RE: Re-estimation of Elevations
Within the Cohasset Flow

Enclosed are the revised 4 pages from the above report that contain a few changes. These changes were necessitated by the fact that the initial one-sided confidence interval as used by Taylor and subsequently used by me in the above report failed to take into account the joint probability of having both BFLT and TFLB satisfy the one-sided confidence interval at the same time.

UNIVERSAL KRIGING UNDER SEVERELY LIMITED DATA

Figure 12. Minimum difference in elevations at 64% confidence interval (Contour interval = 5')

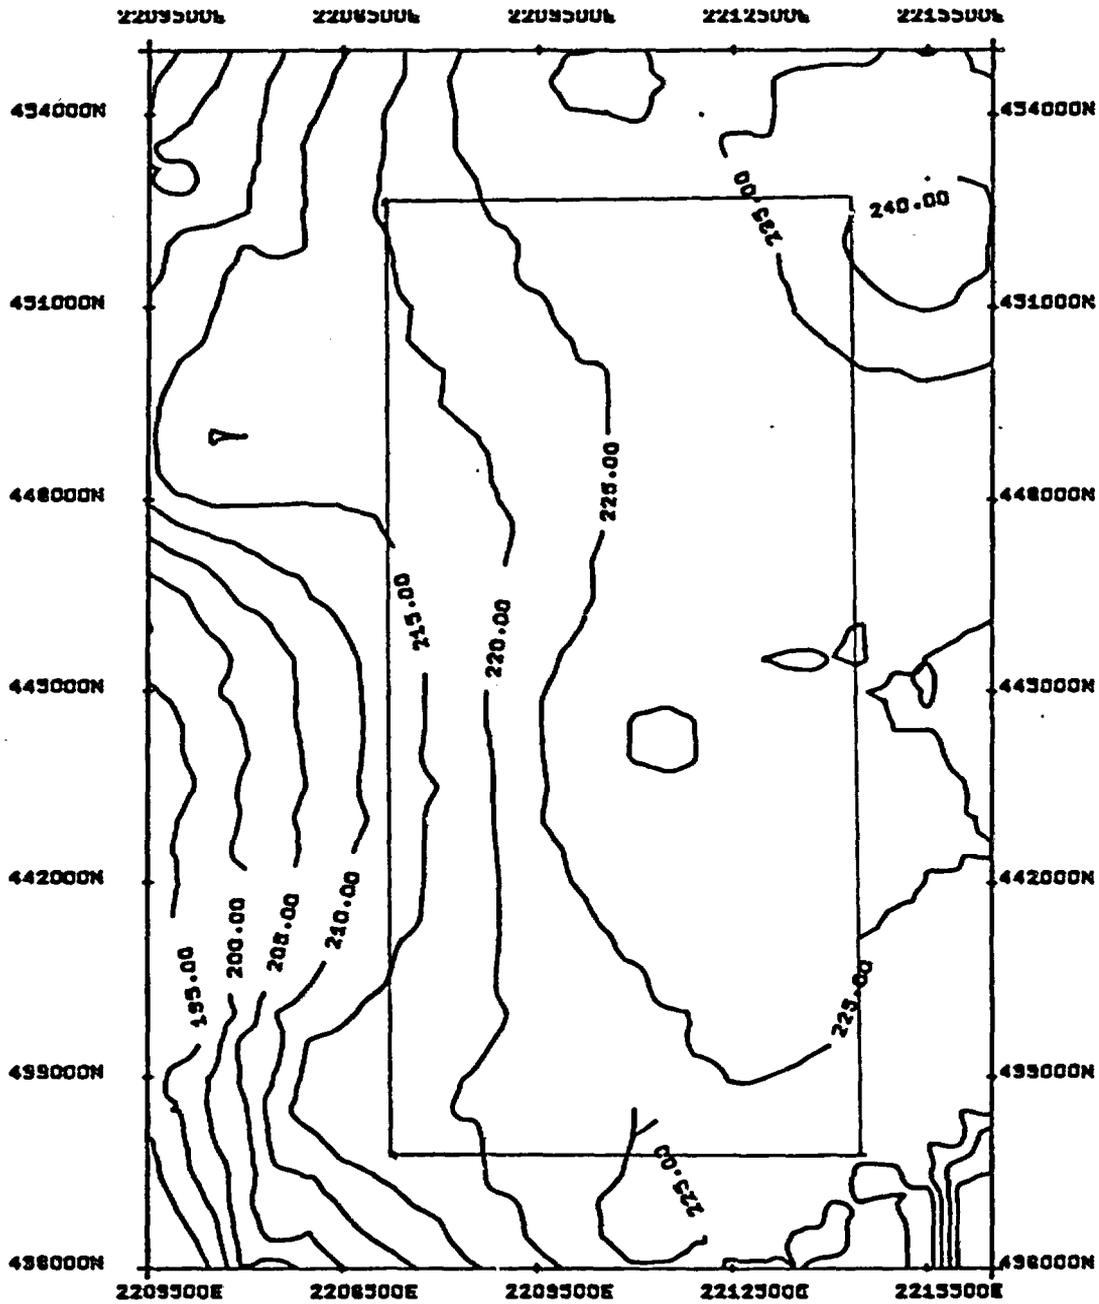
Figure 12 is the contour of the minimum differences at 64% confidence level assuming normality of errors and using one-sided rather than two-sided interval (i.e., $Z = 0.84$ in Eq.4). This 64% confidence level is based on the joint probability of having both BFLT and TFLB satisfy the 80% one sided confidence interval, i.e., $.80 \times .80 = .64$. (Please note that Taylor's 80% C.I. should be changed to 64% as well). From this figure, a minimum thickness of approximately 212' is found along the western edge of the repository layout area, which is different than Taylor's results (See Figure 19 on p. 33). At 90% ($.95 \times .95 = .90$) confidence, the minimum thickness is now reduced to approximately 188' which is still thick enough to satisfy buffer zone requirements of the repository design (See Figure 13).

Figure 13. Minimum difference in elevations at 90% confidence interval (Contour interval = 5')

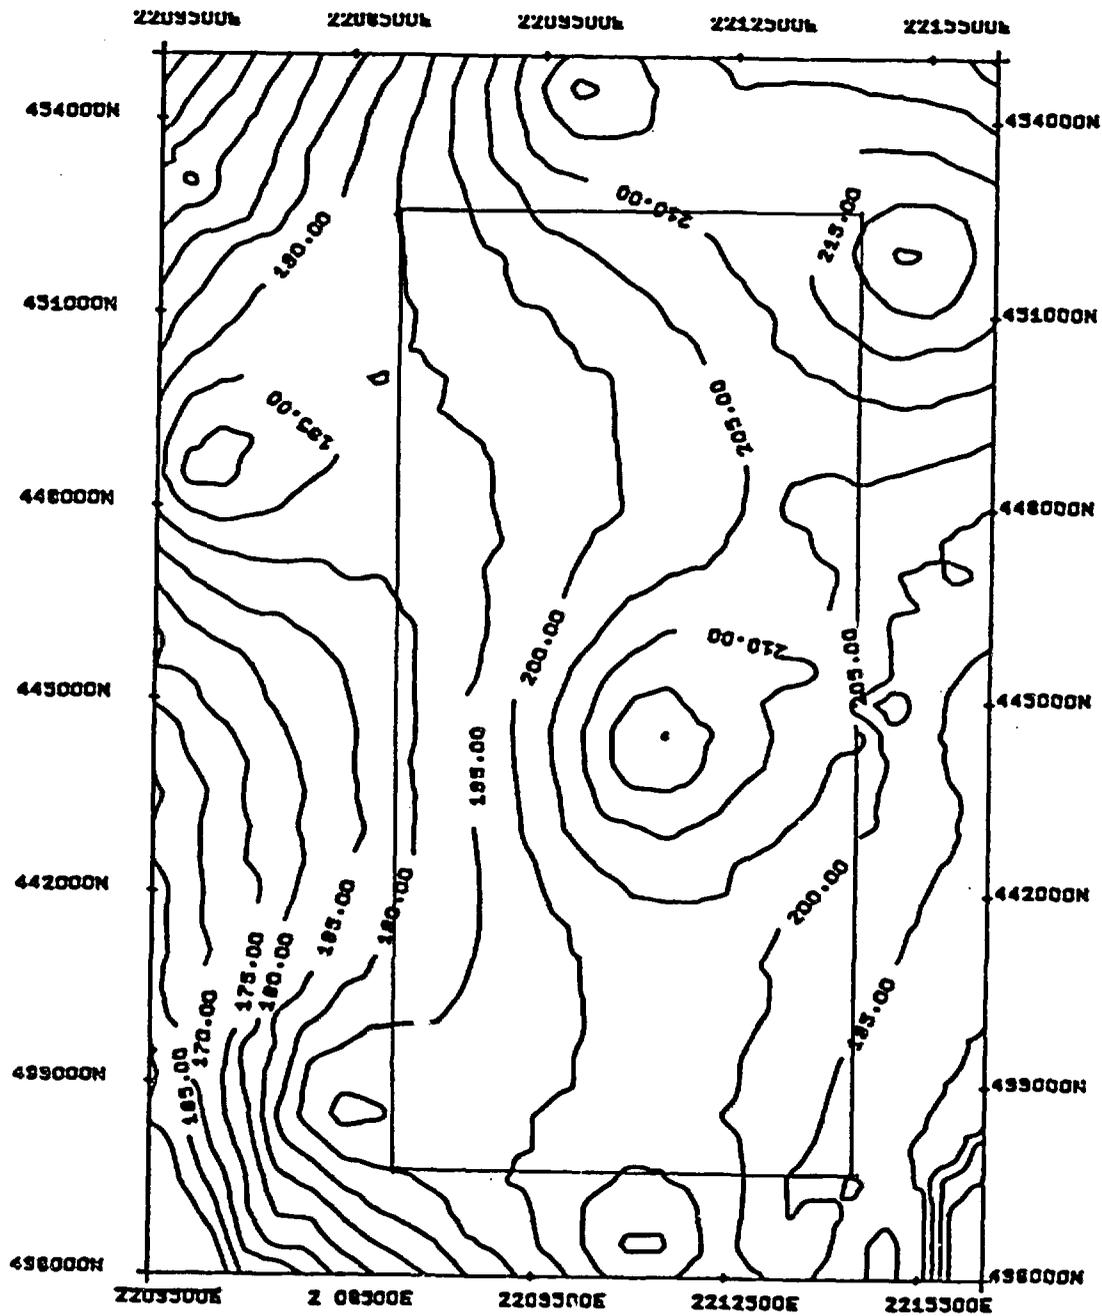
5. Assuming the variogram models represent true underlying spatial correlation of samples and also assuming that there will not be any unexpected findings in the future, the obtained minimum difference in elevations at 90% confidence interval is sufficient to allow the buffer zone requirements of the repository design.
